Model: Finisher SR4010/SR4020	Date: 15-Nov-07	No.: RD373001b
-------------------------------	-----------------	----------------

Subject: Firmware Release Note: Finisher SR4010/SR4020		Prepared by: H.Matsui	
From: 2nd Tech. Support Sec. Service Support Dept.			
Classification:	<input type="checkbox"/> Troubleshooting	<input type="checkbox"/> Part information	<input type="checkbox"/> Action required
	<input type="checkbox"/> Mechanical	<input type="checkbox"/> Electrical	<input type="checkbox"/> Service manual revision
	<input type="checkbox"/> Paper path	<input type="checkbox"/> Transmit/receive	<input type="checkbox"/> Retrofit information
	<input checked="" type="checkbox"/> Other ()	<input checked="" type="checkbox"/> Tier 2

Model: V-C2/MT-C4 Finisher(SR4010/4020/4030/4040)

Subject: SHIELDING PLATE: RIGHT: UPPER

Frame Section (D373/D374)

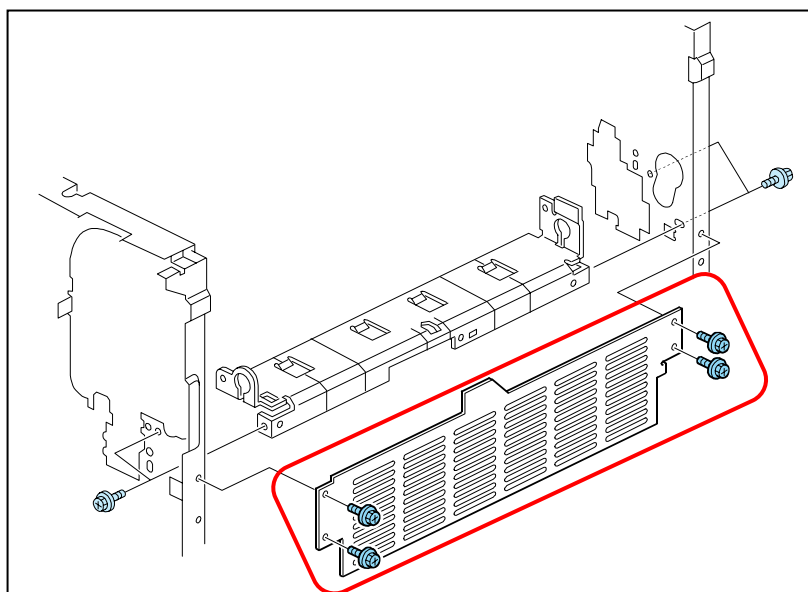
Change: The following part framed in red is added for the following reason.

Reason: To further protect the inside of the SR4010/4020/4030/4040 from being touched.

Note: There is small possibility of the above case, so this change isn't applied to the SR4010/4020/4030/4040 units which have already been installed in the field.

[Stapler Tray (Pg.23 Index#17)]

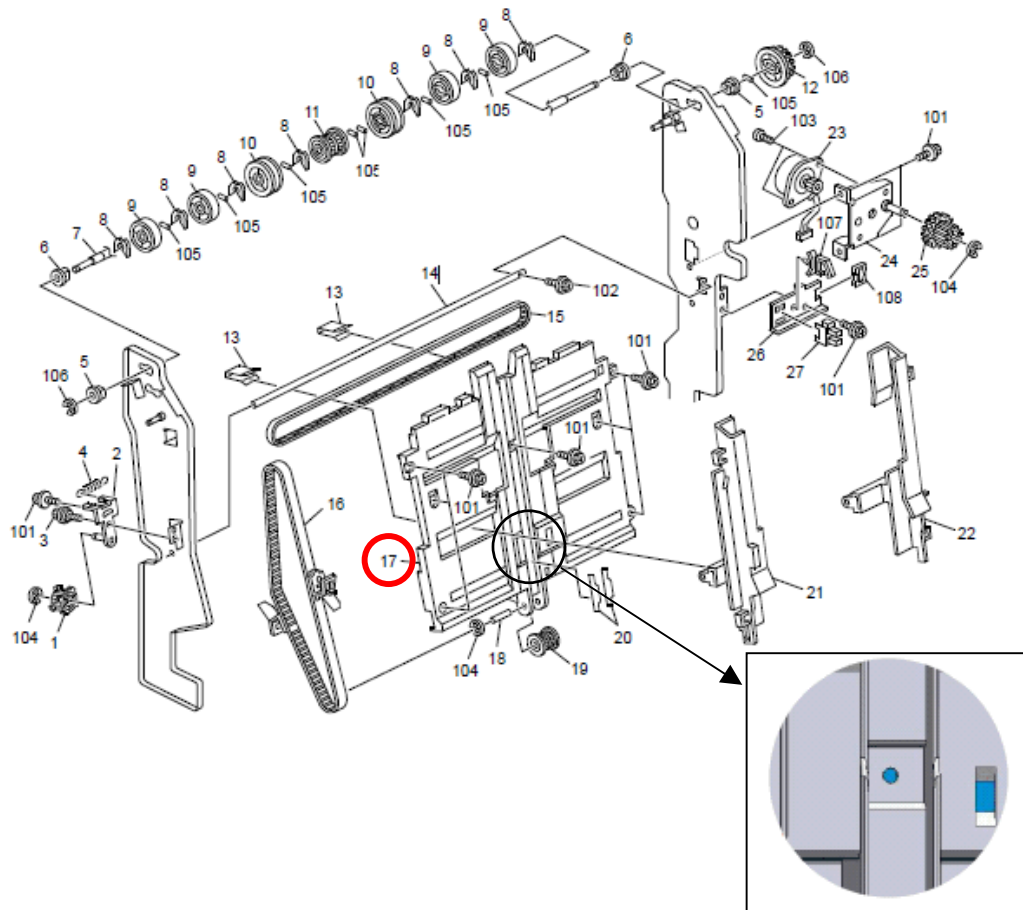
Change: A tapping screw was added for attaching the stapler tray to the lower stay positioning sensor, and screw holes were added as shown below.

Reason: To further improve structural reliability.

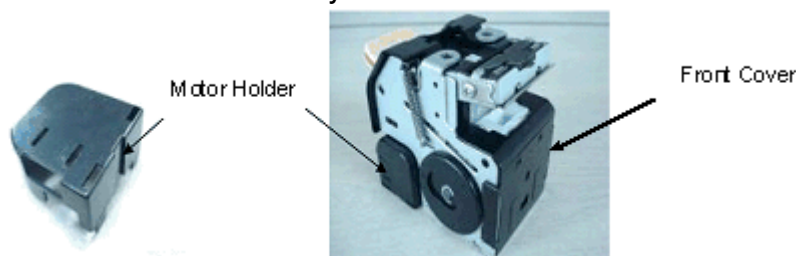
Some parts of the stapler unit (black resin parts shown below) contained PBDE material in excess of the limits set by the RoHS Directive.

The vendor of these parts used irregular materials during the manufacturing process.
 Production period: June to September 2010 (refer to the S/N table below)

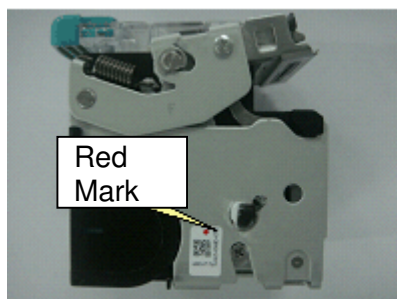
Important: Stapler units on some of these affected finishers have already been replaced with the normal ones. If there is a **red dot** on the stapler unit's label (see the photo below), you **do not need to replace** these units.

The affected stapler unit is shown in the illustration below (Index #24):

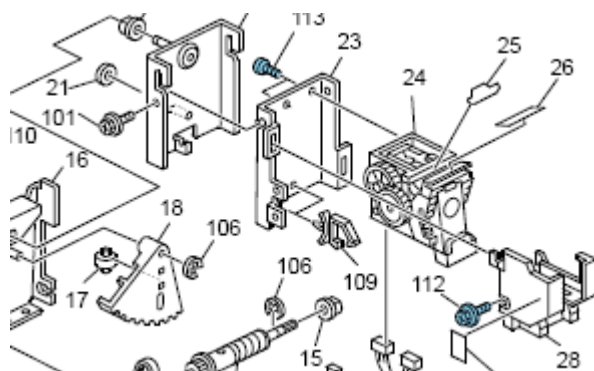
1. These parts contain staplers and Mylars but not cartridges.
2. Stapler units for corner stapling on the affected finishers with the parts that were registered specifically for this issue (also listed below). So, this issue does not apply to booklet stapler units (B7007852), so you do not need to replace these.

New stapler units have been made available for replacement.

Replace the affected stapler units with the following part numbers for the intended models
